**Subject: Cogentrix Quail Brush Generation Project – Docket Number 11-AFC-3,
Supplement 2 to the AFC**

COGENTRIX QUAIL BRUSH GENERATION PROJECT

Supplement 2 to the
Application for Certification

11-AFC-3

FIGURE 1.1-1
PROJECT LAYOUT

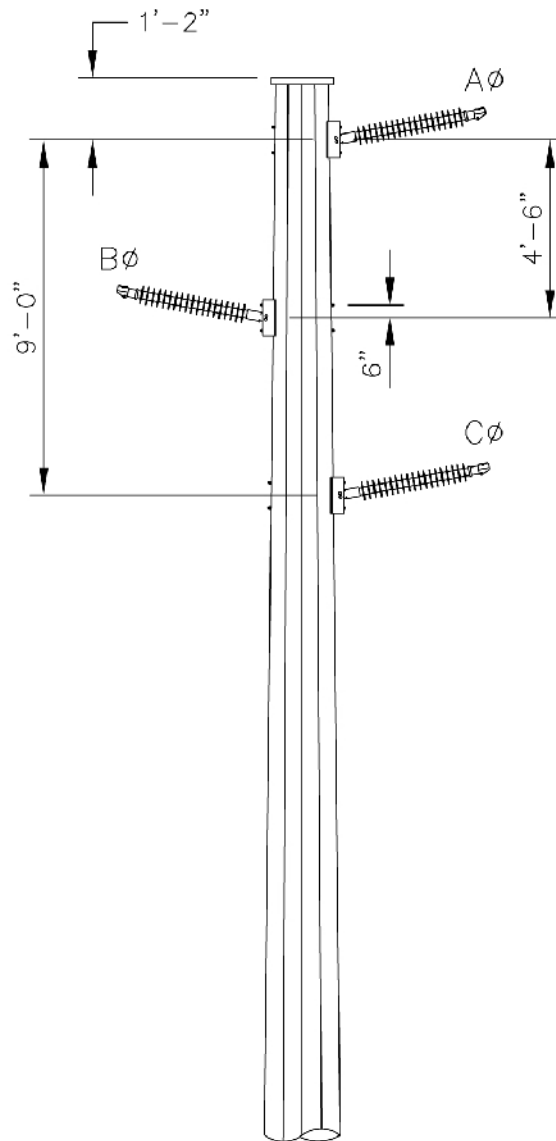
The Project with the 230kV gen tie proposed in the AFC would have connected into SDG&E's Mission-Miguel 230kV transmission line in the transmission corridor that is located northwest of the proposed power plant site. In this Supplement, the Applicant proposes to change the POI to the existing SDG&E Carlton Hills Substation and propose a new 138kV gen tie for the Project. The proposed 138kV gen tie ROW will head north northeast from the proposed power generation site to the south side of the existing east-west SDG&E 138kV transmission line corridor, where it will parallel the existing 138kV transmission line to the east until it reaches the existing Carlton Hills Substation. The proposed 138kV gen tie will require modifications to the existing SDG&E 138kV Carlton Hills Substation. SDG&E will expand the existing 138kV air insulated buswork as required, to accommodate the Project's 138kV gen tie within the existing fence line of the SDG&E Carlton Hills Substation.

The Applicant proposes three alternative alignments to the proposed 138kV gen tie, as described below and shown in Figure 1.1-1. The 230kV gen tie described previously in the AFC, including the SDG&E 230kV utility switchyard described in Section 2.5 of the AFC, will no longer be required for the Project as a result of the proposed interconnection using the 138kV gen tie.

Three alternatives to the proposed 138kV gen tie are also being considered (Figure 1.1-1) as follows:

- **Alternative 1 138kV Gen Tie.** The gen tie would start at the dead-end structure inside the plant switchyard on the north side of the plant. The gen tie ROW would then proceed east for approximately 3,000 feet, and then travel east northeast approximately 2,200 feet (south of and parallel to the existing 138kV transmission lines) to the Carlton Hills Substation. The total length of the Alternative 1 138kV gen tie between the plant site and the substation is approximately one mile.

- **Alternative 2 138kV Gen Tie.** The gen tie will start at the dead-end structure inside the plant switchyard on the north side of the plant. The gen tie ROW would then proceed north, east of Sycamore Landfill Road for approximately 1,350 feet, then travel northeast for approximately 900 feet, where it will turn eastward for approximately 2,300 feet (south of and parallel to the existing 138kV transmission lines), then cross under (from south to north) the existing SDG&E 138kV transmission lines. The gen tie will then travel east northeast for approximately 2,200 feet (north of and parallel to the existing 138kV transmission lines) to the Carlton Hills Substation. The total length of Alternative 2 138kV gen tie between the power plant site and the substation is approximately 6,750 feet.

- **Alternative 3 138kV Gen Tie.** This alternative would start at the dead-end structure inside the plant switchyard on the north side of the power plant. The gen tie will then proceed north, east of Sycamore Landfill Road (a private road) for approximately 2,050 feet, and then turn eastward (south of and parallel to the existing 138kV transmission lines) to the SDG&E 138kV Carlton Hills Substation. The total length of Alternate 3 138kV gen tie between the power plant site and the substation is approximately 7,800 feet.

FIGURE 2.3-1
GEN-TIE
138 kV TRANSMISSION LINE
"WPI"
POLE TOP ARRANGEMENT

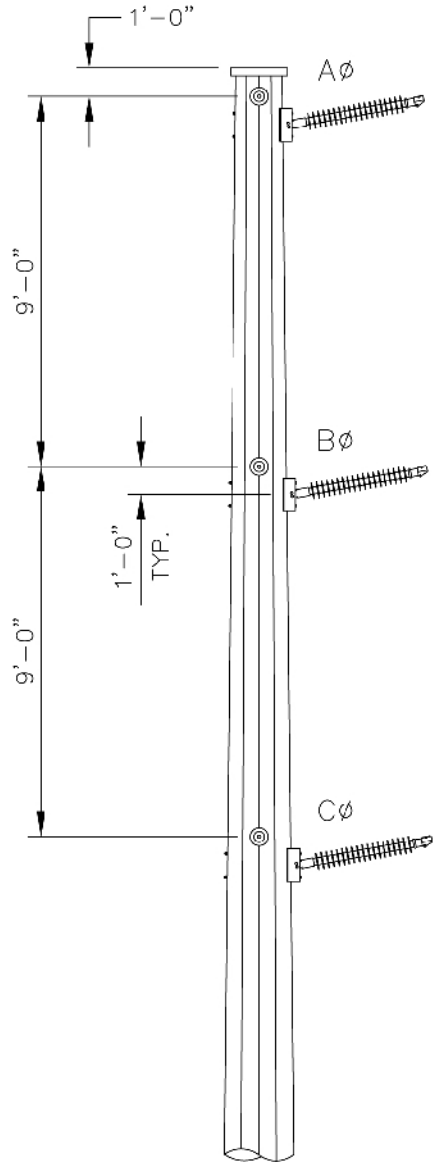
The proposed 138kV gen tie will be designed to carry the full output of the plant at 138kV. The gen tie will be arrayed in a single-circuit configuration, supported by steel structures placed at appropriate intervals. The overhead line conductor type (Table 2.3-1) to be considered will be 477 thousand circular mil (kcmil) Aluminum Conductor, Steel Supported (ACSS) Cable (Hawk).

The proposed 138kV gen tie will exit the plant switchyard in a slack span configuration from the dead-end structures (approximately 60 feet tall) on the north side of the plant site. From that structure, the gen tie will travel north then east with an average span of 400 to 600 feet. Depending on the final routing of the gen tie, heavy-angle structures will be placed as required for a distance of approximately 6,850 feet to accommodate changes in direction of the line. The remaining new pole structures will be tangent-type design and will be spaced based on engineering criteria. The new pole structures will be approximately 65 to 85 feet tall. See the structure framing drawings for each of the (3) steel pole types (Figures 2.3-1, 2.3-2, and 2.3-3) that are to be utilized. A 477 kcmil ACSS (Hawk) conductor has been chosen and has sufficient capacity to carry required current.
